Groundwater Application Review Summary Form

Application # LL- 1991

SUBJECT: Scenic Waterway Interference Evaluation

TO: Water Rights Section Date 9/30/2024
 FROM: Groundwater Section Stacey Garrison/James Hootsmans
 Reviewer's Name
 SUBJECT: Application LL- 1991* Supersedes review of _____
 Date of Review(s)

Theis Drawdown

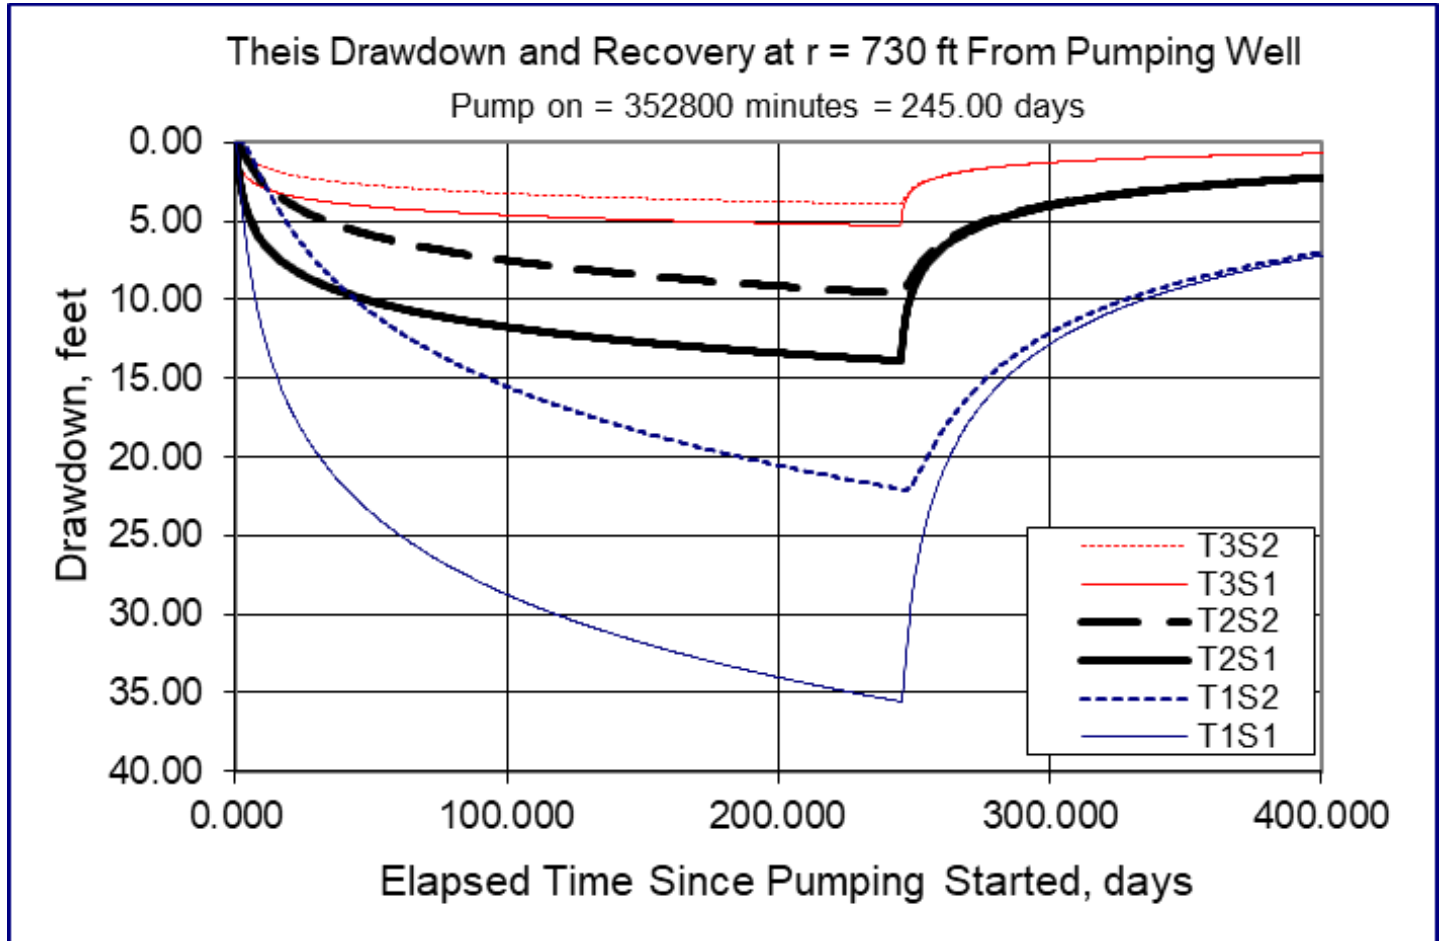
The nearest groundwater user to one of the POAs is likely the domestic well serving tax lot 400 at 16361 NW Red Shot Lane, with an estimated location 730 ft northeast of POA 3 (YAMH 55946), at an elevation of 415 ft amsl. It is likely the proposed use would cause some degree of well-to-well interference with the domestic well serving tax lot 400. To assess the degree of drawdown, a Theis drawdown analysis was conducted for the proposed use (see Theis Drawdown Analysis). Results indicate

that the proposed use is not likely to cause well-to-well interference with the domestic well serving tax lot 800 that exceeds the threshold under the standard condition for aquifers in the Willamette Basin. Because only the distance varies between the POAs and each respective closest groundwater user, only the pair with the shortest distance was modeled (POA 3 and tax lot 400); drawdown between all other POAs and the respective closest groundwater user is anticipated to be less than modeled. Based on this analysis of the available data and under the assumptions previously identified, groundwater for the proposed use will likely be available in the amounts requested and within capacity of the resource. The conditions specified in B1(d)(i) and B2(c) are recommended to protect senior users and the groundwater resource.

Radial distance from pumping well (r)=730 ft [estimated radial distance to nearest user, 16361 NW Red Shot Lane, TL 400]

Pumping Rate (Q)= 0.0557 cfs (~25 gpm)

Aquifer Transmissivity (T1)= 3,74 gpd/ft (50 ft²/day), (T2)= 1,197 gpd/ft (160 ft²/day), (T3)= 3,740 gpd/ft (500 ft²/day)

Storativity (s1) = 0.00005, (s2) = 0.003 [Conlon et al 2005, Table 1 and 2 values for BCU]

Total pumping time=245 days [Irrigation March 1 through October 31]
